Re: G & H Landfill Comments on PRAP and RI/FS

**COMMENTS ON THE PROPOSED REMEDIAL
ACTION PLAN AND REMEDIAL INVESTIGATION/
FEASIBILITY STUDY**

**G & H Landfill Site
Shelby Township, Michigan**

**OCTOBER 1990
REF. NO. 1989 (11)**

figure 2.4
WATER BALANCE
CRA ESTIMATE FOR PRAP PREFERRED REMEDY
G & H Landfill

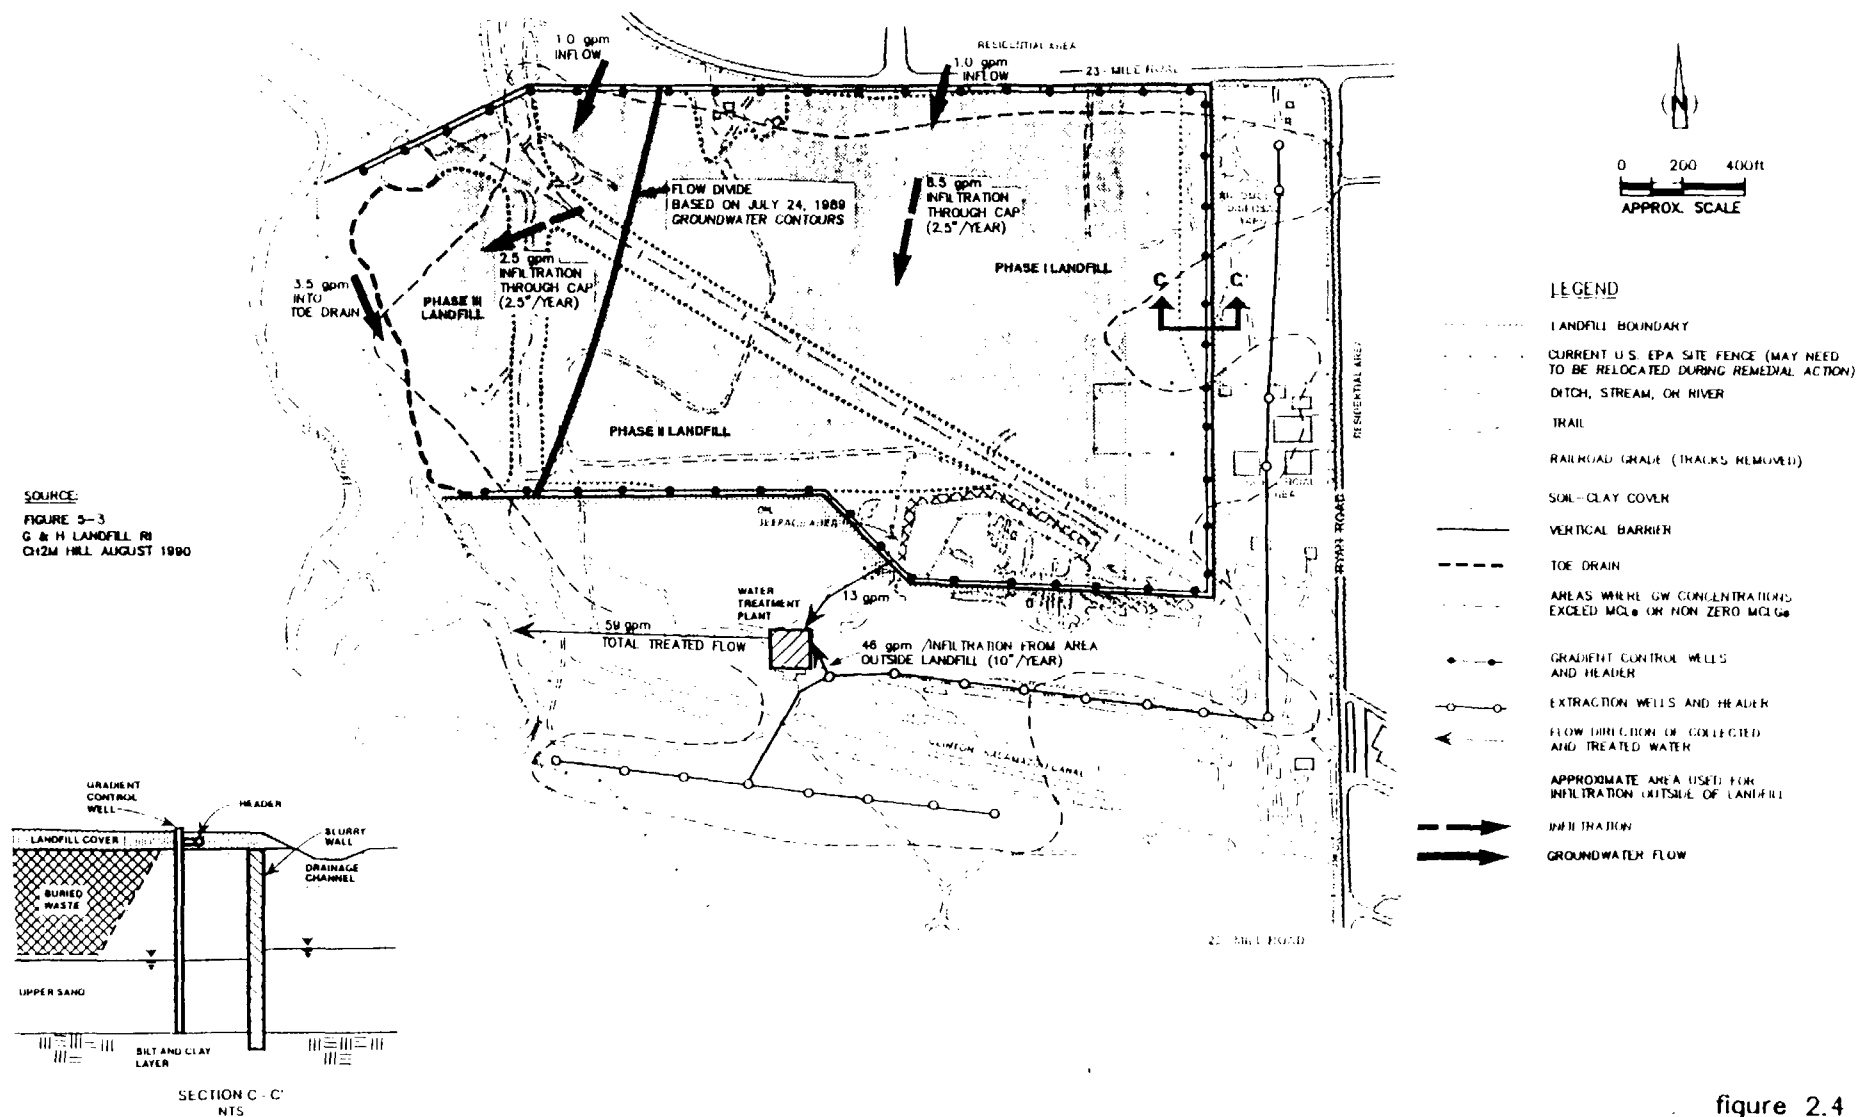
If a landfill cap and a vertical barrier slurry wall are installed, as proposed in the PRAP, it is expected that the water balance would be as presented on Figure 2.4.

With the PRAP preferred remedy, it is estimated that 3.5 gpm would be collected by the drain on the west side of the Phase III landfill, an additional 9.5 gpm would be collected by the perimeter gradient control wells and 46 gpm would be collected from the plume control extraction wells. The total volume of groundwater water requiring treatment is estimated to be 59 gpm. After the chemicals are reduced to below the clean up goals, the long term flow requiring treatment would be 13 gpm for the PRAP preferred remedy. This reduction in pumping is not expected to occur for at least 35 years.

It should also be noted that operation of the 47 gradient control wells each pumping less than 1/4 gpm of leachate, as specified in the PRAP preferred remedy will result in frequent long term operation and maintenance problems.

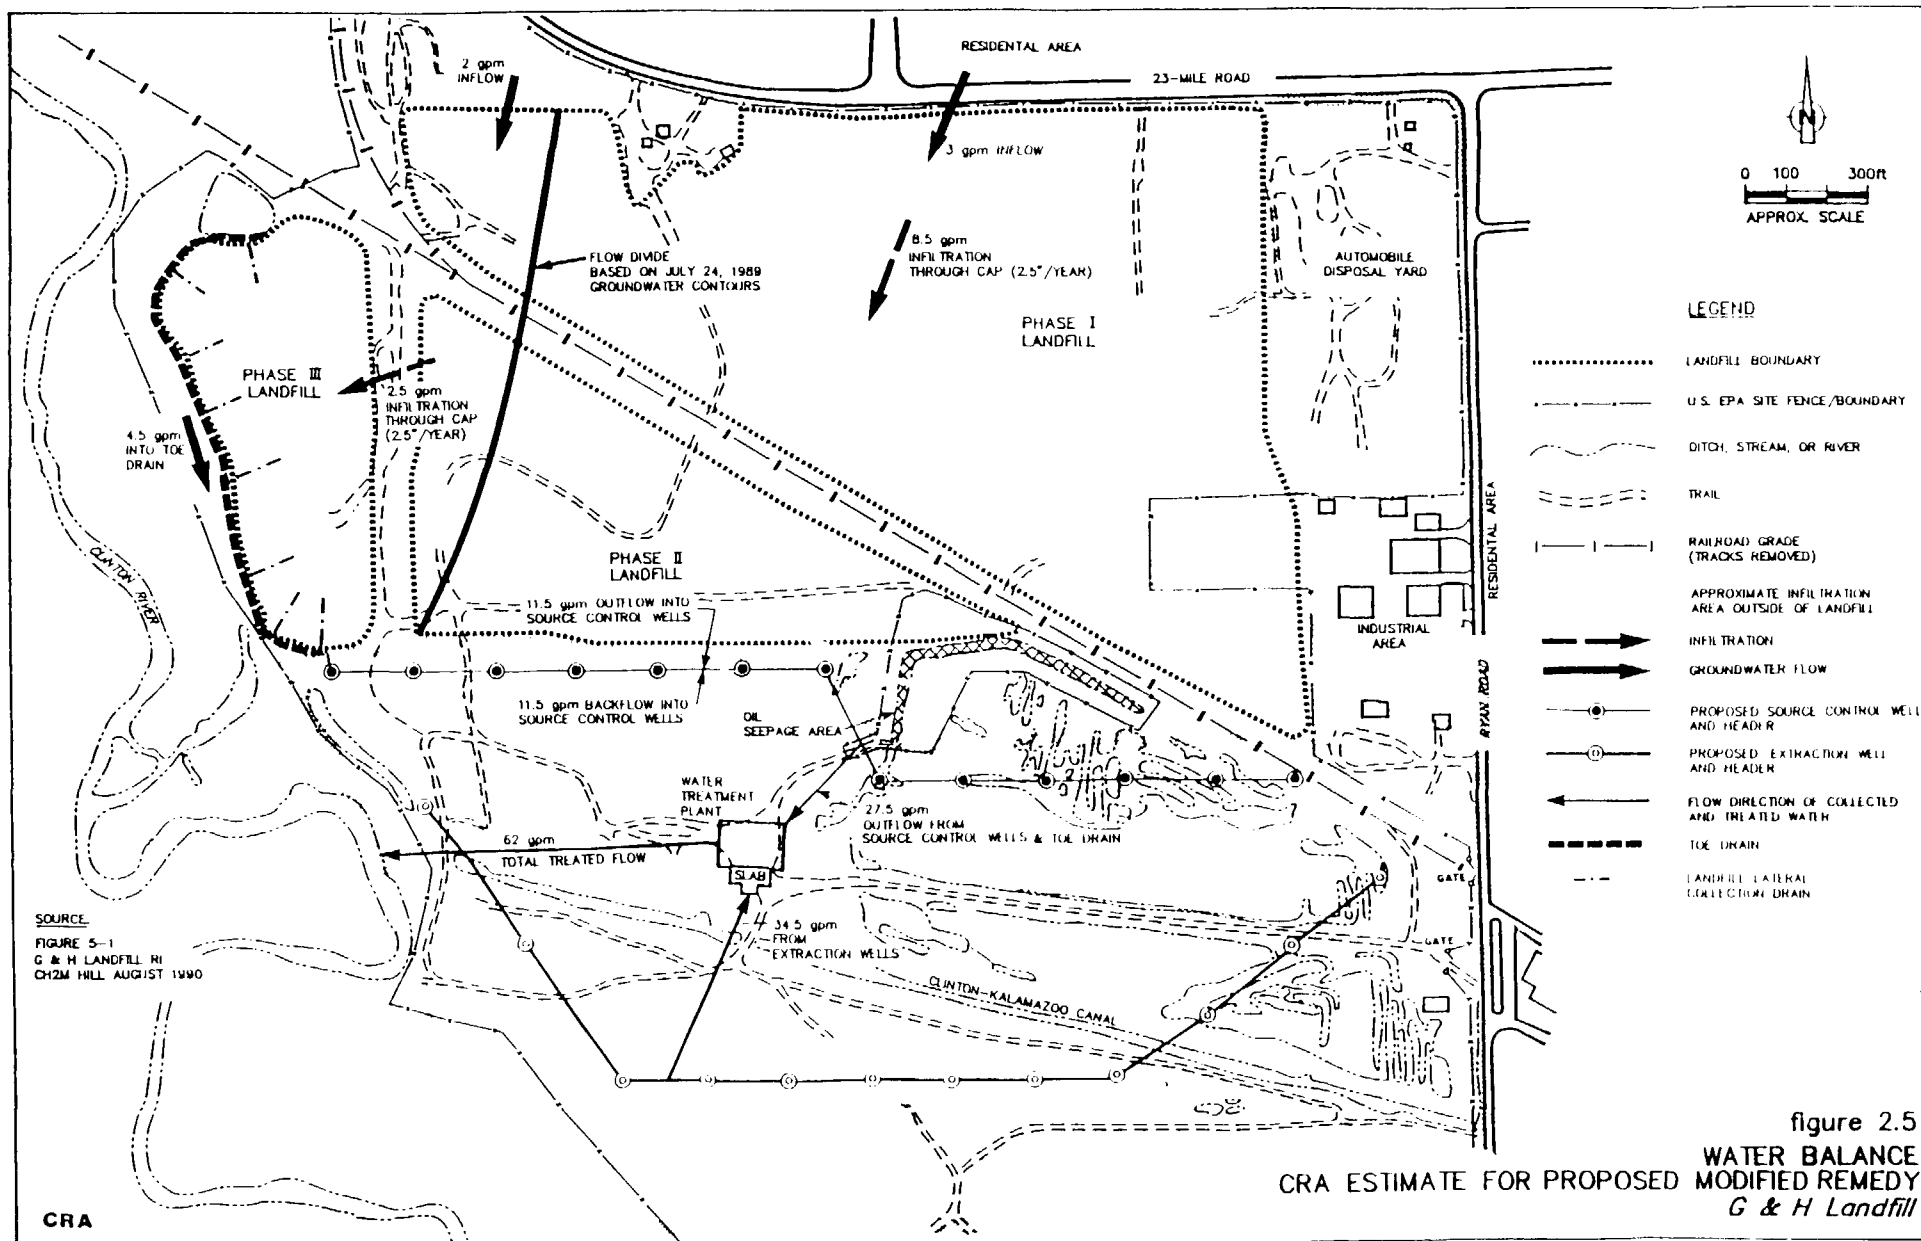
and isolate the landfill. It is estimated that 13 source control wells could replace both the slurry wall and 47 gradient control wells, yet provide the same overall benefit. Figure 2.5 presents the water balance for this proposed modified remedy. With the 13 source control wells, while retaining the toe drain from the PRAP preferred remedy, the landfill would be hydraulically contained. With this proposed modified remedy, it is estimated that 4.5 gpm would be collected by the toe drain on the west side of the Phase III landfill, an additional 23 gpm would be collected by the source control wells and 34.5 gpm would be collected from the extraction wells. The total volume of water requiring treatment is estimated to be 62 gpm, which is only 3 gpm more than the PRAP preferred remedy. After the chemicals in the groundwater are reduced to below the clean up goals the long term flow requiring treatment would be approximately 27.5 gpm for this system. This reduction in pumping is also not expected to occur for at least 35 years.

Figure 2.5 presents the source control and groundwater extraction well locations for the proposed modified remedy. The number of groundwater extraction wells can be reduced from 20 to 12 wells by eliminating redundancy in the U.S. EPA design. A better designed system will achieve the same objectives while reducing cost. The PRAP proposed groundwater extraction wells off Site to the east would be eliminated as they address problems not related to the Site. The toe drain on the west side of the Phase III landfill would be upgraded to include laterals and is included in the proposed modified remedy. As presented previously, the total volume of water requiring treatment for the first 35 years would be 62 gpm which is only 3 gpm more than the PRAP preferred remedy. It is expected that under this scenario 4.5 gpm would be collected by the toe drain, 23 gpm would be collected by the source control wells and that 34.5 gpm would be collected at the groundwater extraction wells. This system would require that 27.5 gpm be treated once the groundwater was remediated. The additional water requiring treatment in the long term would include 3 gpm entering the Site on the upgradient side and 11.5 gpm of clean water being drawn back by the source control wells once the groundwater extraction wells are shut off.
